Reply to Office Action of February 6, 2008

AMENDMENTS TO THE DRAWINGS:

U.S. Reissue Application No.: 09/986,720 Inventor: Thierry PONTON Attorney Docket No.: 5725.0867 Reply to Office Action of February 6, 2008

FIG. 3A

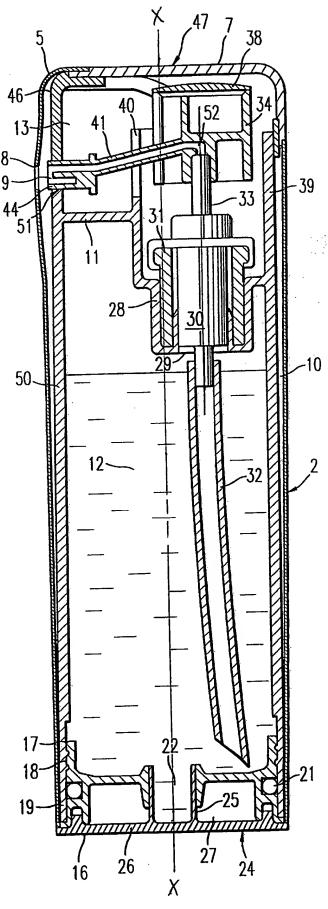
Please amend Fig. 3A to show an axis X of the container and an axis of the

pump 30, as shown in red ink on the attached drawing sheet labeled "Annotated

The drawings were objected to, allegedly because "the axis of said container and in a direction such that the axis of said pump is farther from the product outlet than is the axis of said container," a version of which is recited in claims 8, 28-30, 43, 55, 70, 90, and 91, is not shown in the drawing figures. Office Action at 2-3. By this Amendment, Applicant has amended Fig. 3A to show an axis X of the container and an

axis of the pump 30, as shown in red ink on the attached drawing sheet labeled "Annotated Marked-up Drawing." This amendment is incorporated in the attached "Replacement" drawing sheet containing amended Fig. 3A, which has been labeled "Amended." Support for these amendments to the drawings is found at least at column 5, line 64 through col. 6, line 3 of the patent.
